CITY OF ALBUQUERQUE

**Re: Lot 8 Block 8 SAD 227
Volcano Cliffs Subdivision Unit 5
6100 Casa Blanca Dr. NW
Grading and Drainage Plan
Engineers Stamp Date 8/21/2020 (E10D084)
Pad Certification Date 9/3/2021
CO Certification Dated: 5/11/2022**

| | GRADING AND DRAINAGE PLAN | DATE 8-20-20 |

| | | SHEET # C1 |

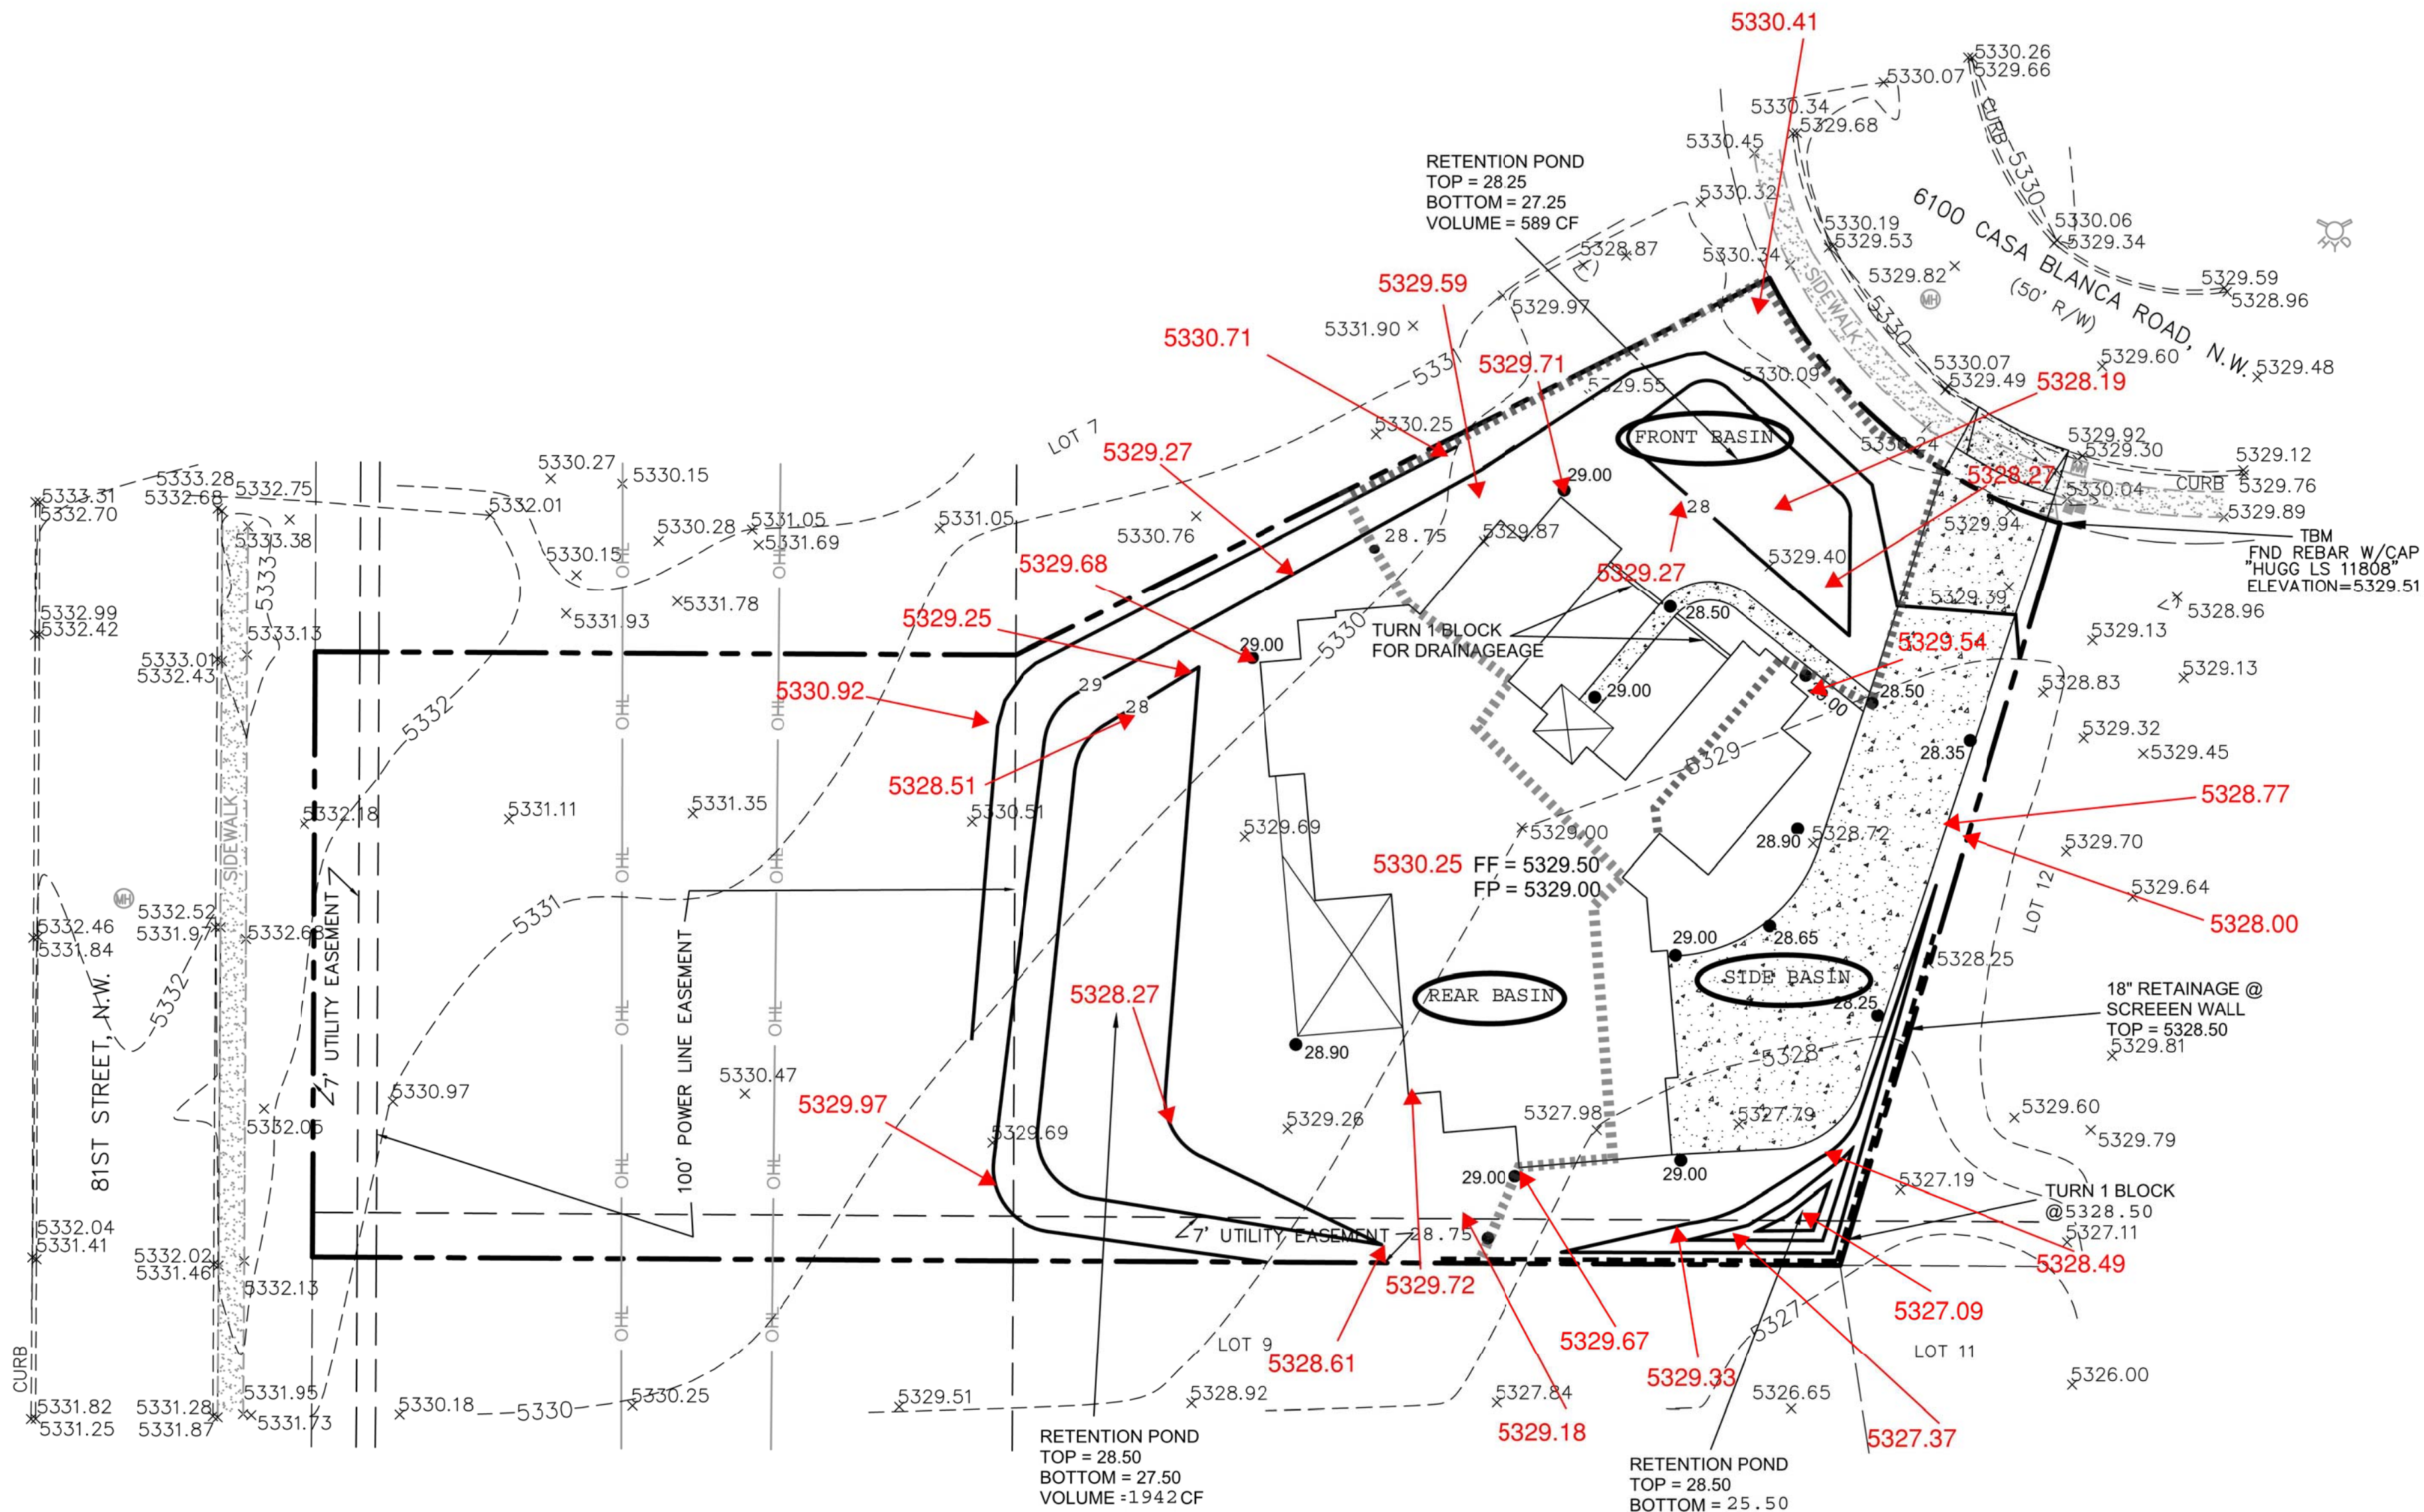
Based on the Certification received on 5/11/2022, the site is acceptable for release of
Certificate of Occupancy by Hydrology.
